Supplementary Design Report
Response to Submissions
Central State Significant Precinct
Western Gateway - Block C

Project Name Central State Significant Precinct - Western Gateway - Block C
Project Code TAC
Document Name Response to Submissions
Document ID 210317 RTS

This report has been prepared by fjmtstudio in response to the NSW Department of Planning and Infrastructure Submissions Summary dated March 2021 and Project Review Panel Report dated May 2021.

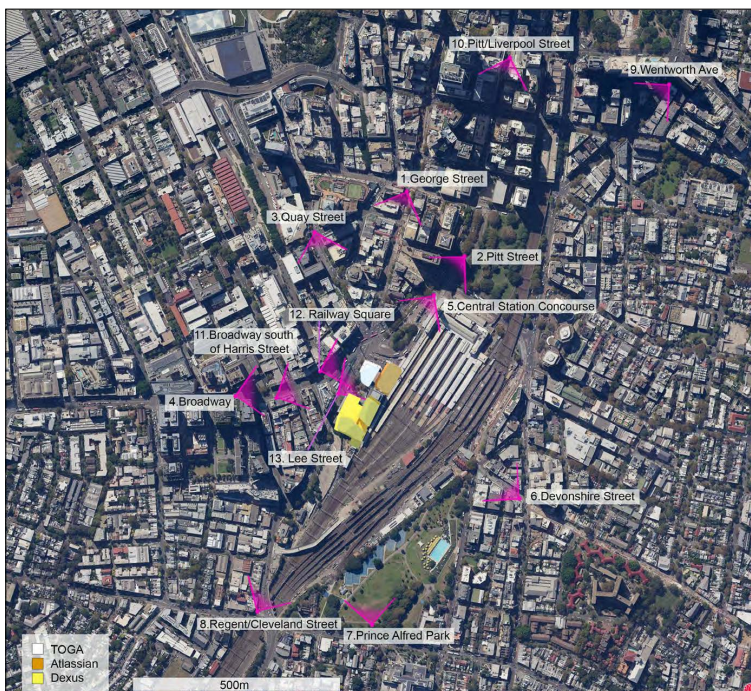
The view and visual impact analysis does not consider appropriate views and the proposal will result in negative impacts on existing views and vistas of Central Station and its surrounds.

The significant views identified in the Sydney DCP 2012 (Special Character Areas 2.1.11- Railway Square/Central Station Special Character Area) have been included in the analysis of view impacts and determination of urban form envelope and setbacks.

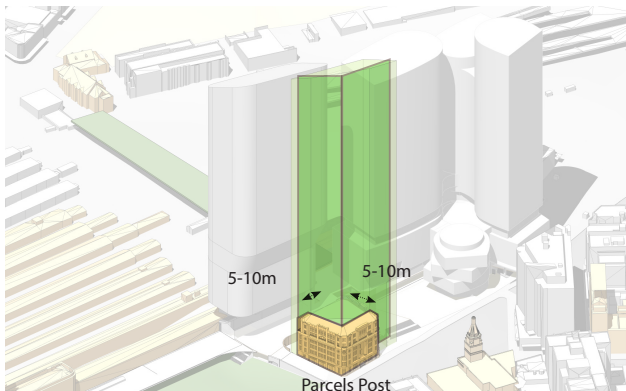
In order to preserve the heritage significance of the former Parcels Post building any new development needs to be adequately setback from the heritage facades, specifically the northern and western facades. A number of submissions raised concerns that the setbacks established through the four SDRP sessions in 2020 are not sufficient.

The key consideration of the north and western setback condition was to maintain the visual prominence of the former Parcels Post building within a future setting.

The new tower has been setback substantially from the north west corner which is the most effective setback when viewed from significant positions on Quay St, Railway Square, George Street and Broadway. The planning envelope includes a 5-10m minimum setback from the northern and western façades.

West Elevation - Vertical Separation Zone

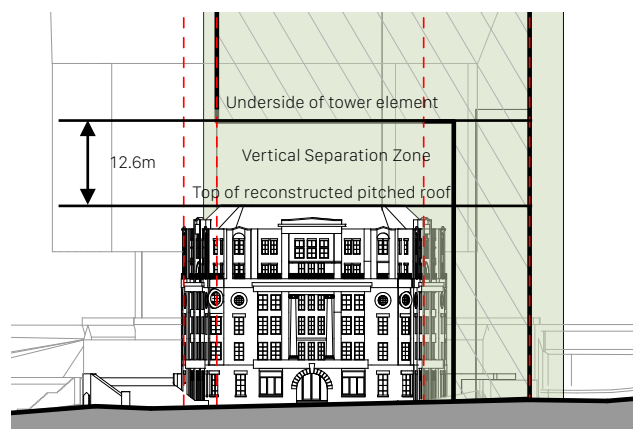
The reference design shows the zone between the fPPb and the base of the tower as enclosed. This does not result in appropriate curtilage to the heritage building.

The proposed envelope identified the area between the roof of the fPPb and the underside of the proposed tower as a Vertical Separation Zone.

No enclosure is proposed in this Vertical Separation Zone except for structural support (refer planning report). This modified approach addresses the PRP request for further metrics, evidence and analysis in the Vertical Separation Zone.
